Case No. 16-131-EL-BGA

# AMENDMENT APPLICATION TO THE Ohio Power Siting Board FOR A Certificate of Environmental Compatibility and Public Need FOR THE Lordstown Energy Center

SUBMITTED BY: Clean Energy Future - Lordstown, LLC

January 2016

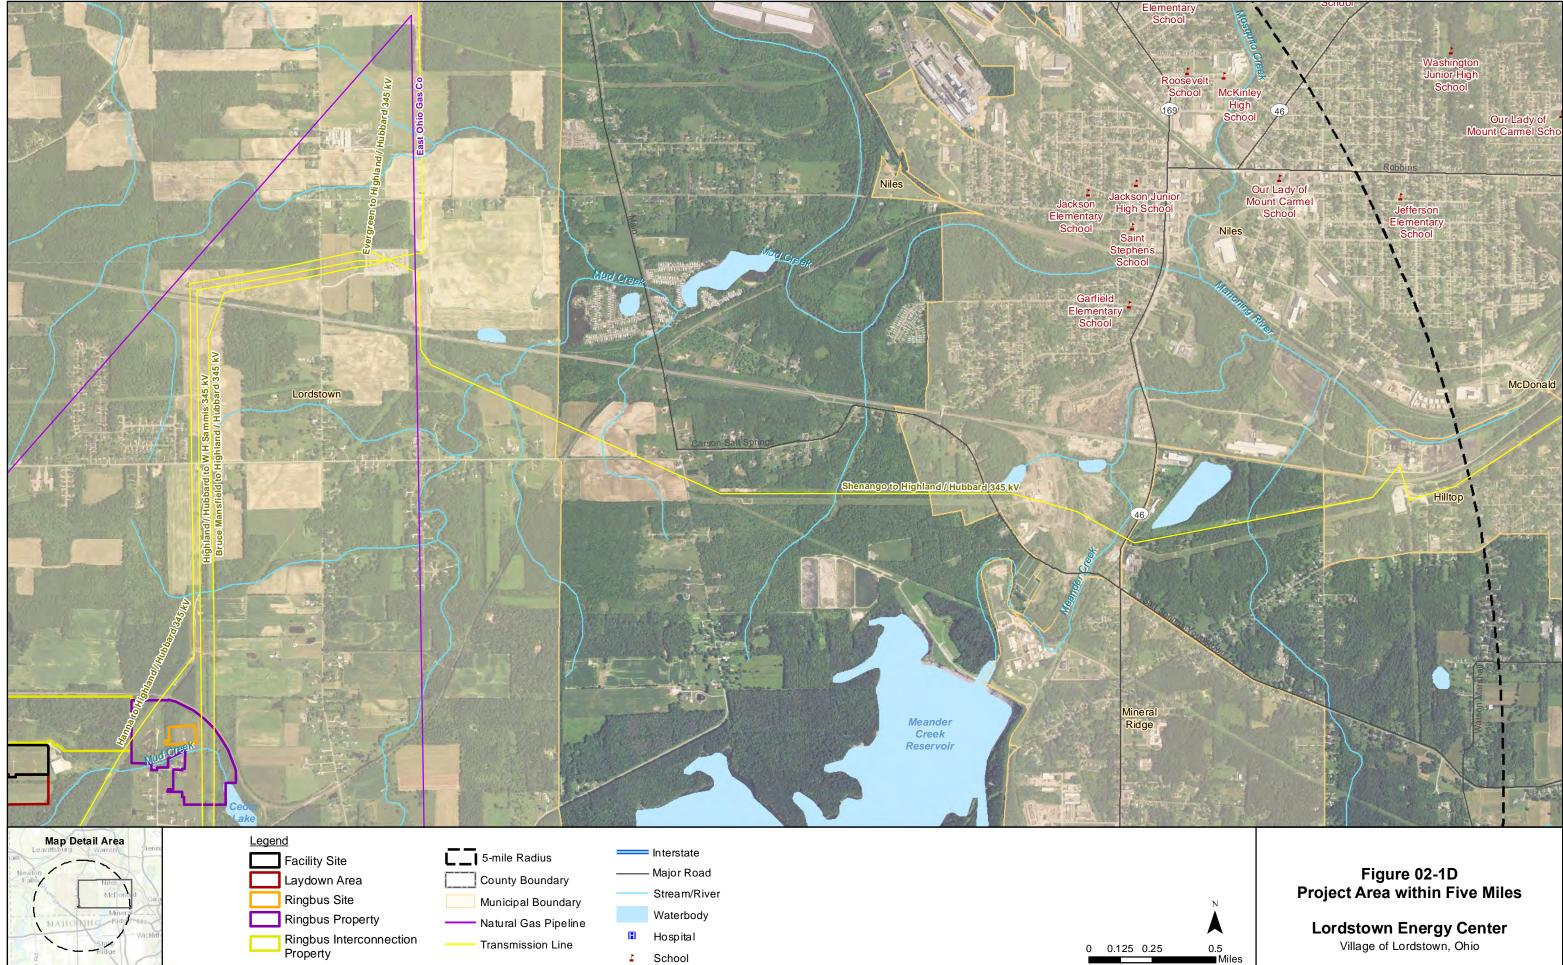
FirstEnergy requested that the layout of the ringbus be rotated, as shown in Figure 01-1, to better meet its design requirements and minimize the cost of their "looping" of their existing double-circuit 345-kV lines into the ringbus. This layout adjustment slightly increased the acreage needed for the ringbus from the originally proposed 3.5 acres to approximately 4.5 acres (Ringbus Site). The entire Ringbus Site remains within the 71-acre optioned property located between the two FirstEnergy 345-kilovolt (kV) transmission line corridors (Ringbus Property). This minor engineering adjustment has a capital cost savings of \$4.1 million, which, in turn, would reduce costs to ratepayers.

R:\Projects 2	2014\Lordstown	\maps\OPSE	3/Fiaure 02-	6 Rinabus	Lavout.mxd

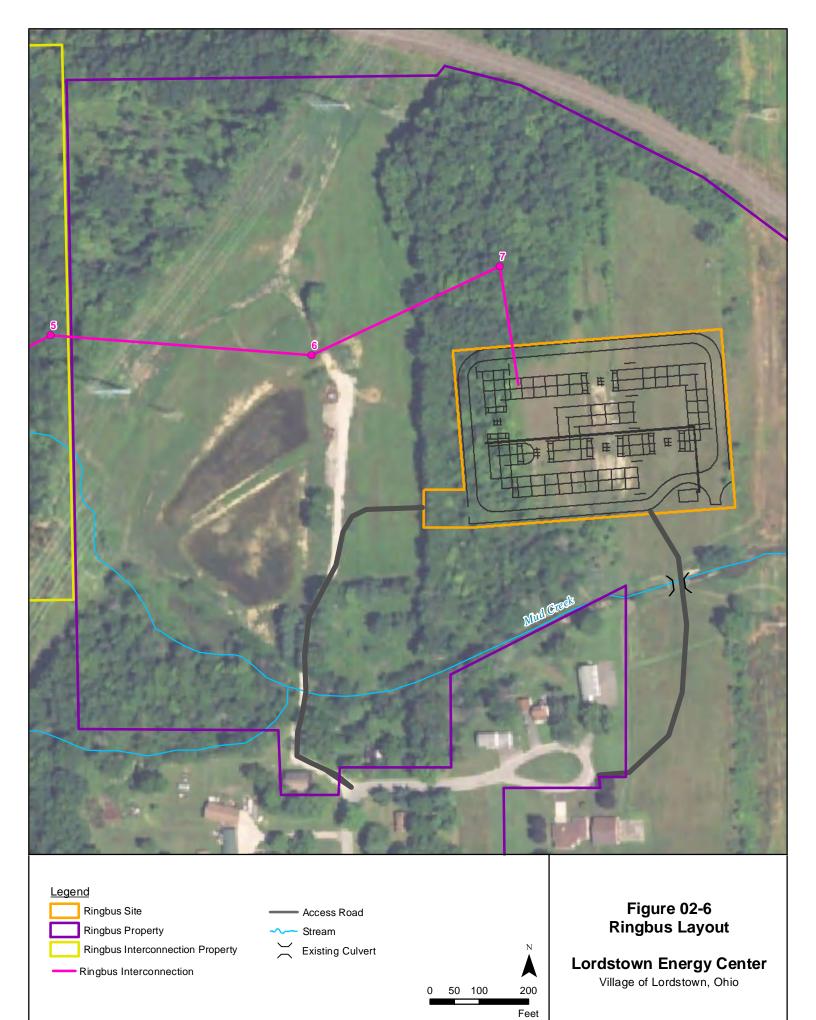
The intention is to subdivide the specific area to be used for the ringbus, such that when the ringbus is built, it can be conveyed (with the land) to FirstEnergy. First Energy will be able to reach the Ringbus Site via a new access road to be built from the end of Goldner Lane, crossing Mud Creek using an existing culvert. The updated ringbus conceptual design (Figure 02-6) was developed with input from FirstEnergy.

The adjusted Ringbus layout is provided in Figure 02-6 and the adjusted route for the Ringbus Interconnection is provided in Figure 02-7. No other change since original filing.

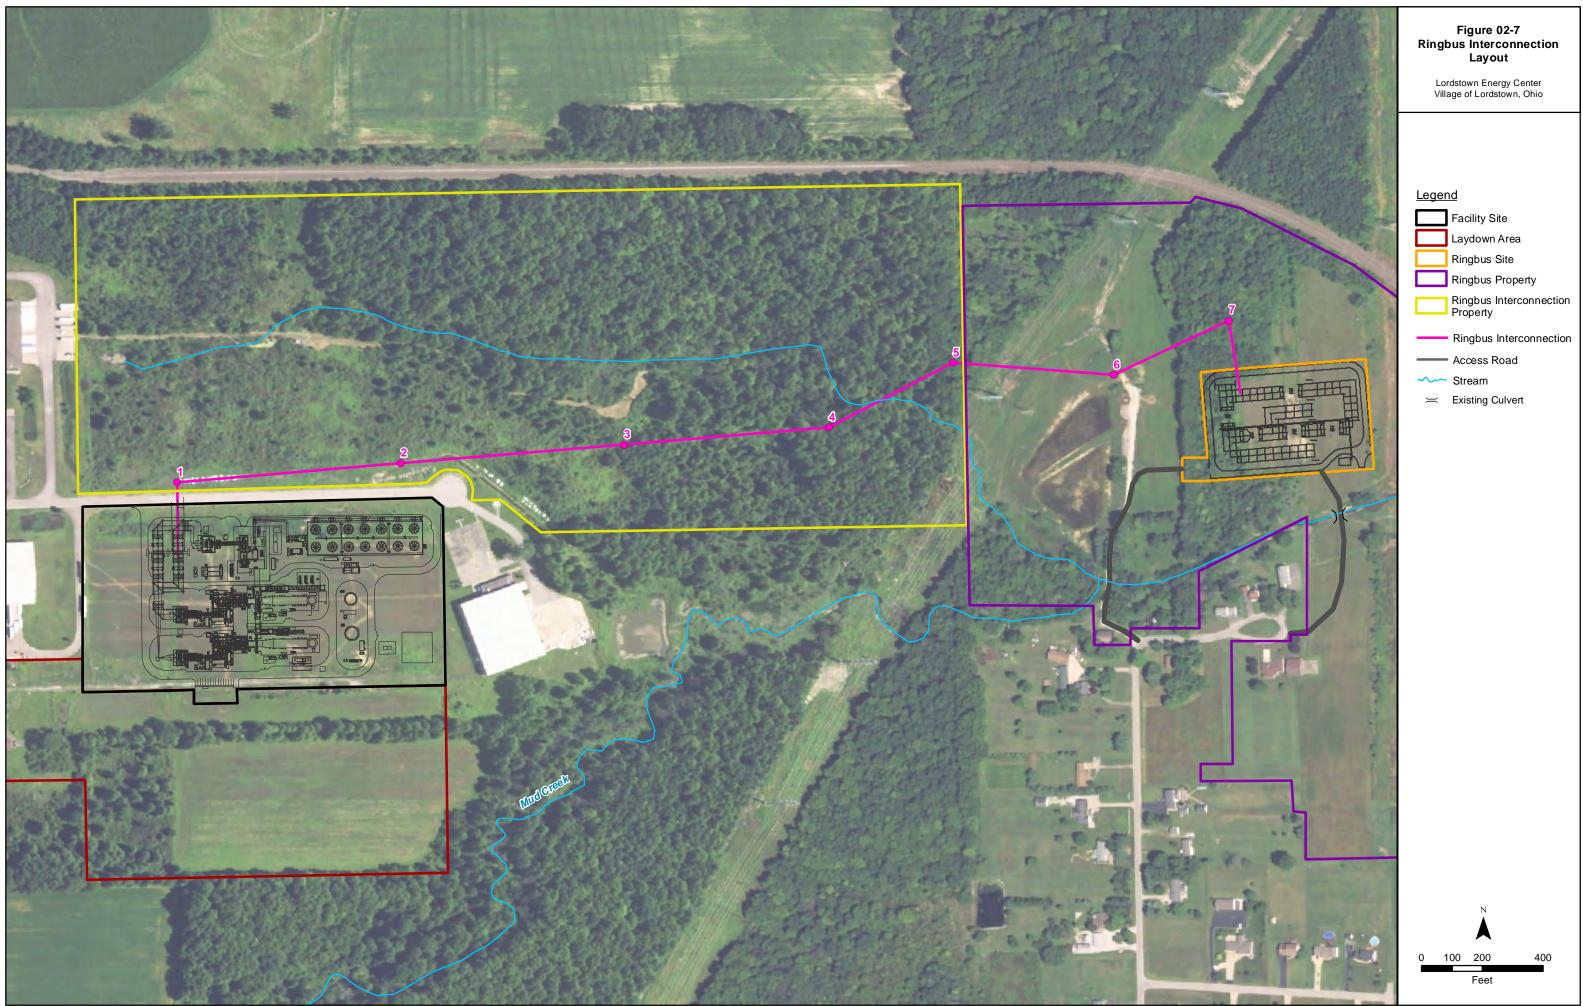
At the request of FirstEnergy, slight adjustments have been made to the Ringbus Interconnection. Conductors from the Facility will cross Henn Parkway in a northerly direction from the on-site collector bus and immediately be connected to Pole 1, a single steel pole, allowing the lines to make a 90 degree turn to the east. Poles 2, 3, and 4 will also be single steel poles, each approximately 750 feet apart in an easterly heading and within a 100-foot ROW. The poles are proposed in such a way as to avoid any construction in existing wetlands while also minimizing tree clearing.

Pole 5 will bring the Ringbus Interconnection to the edge of the FirstEnergy ROW containing the Highland to Hanna 345-kV circuit and the 138-kV circuit. FirstEnergy recently completed a construction project to "lift" the Highland to Hanna 345-kV circuit from an H-style three wooden pole design to a single metal pole design. The adjacent 138-kV system remains on a metal truss-tower structure. Based upon coordination with First Energy, the Ringbus Interconnection will be constructed under First Energy's existing lines. In order to do so, Pole 5 will be a more traditional H-design. Pole 5 has

been shifted northward to allow for a longer span of the FirstEnergy ROW. The adjusted location moves the crossing north of FirstEnergy's new 170-foot steel pole, eliminating the need for a costly "lift" of the existing pole for construction of the new line.

As shown in Figure 02-7, Pole 6, another H-tower, lies east of the First Energy ROW. The Ringbus Interconnection will proceed from Pole 6 in a northeast direction to Pole 7, a single steel pole, which allows the lines to make a 90 degree turn to the south. From Pole 7, the conductors will proceed south into the northwest corner of the Ringbus Site, into a dead-end structure.
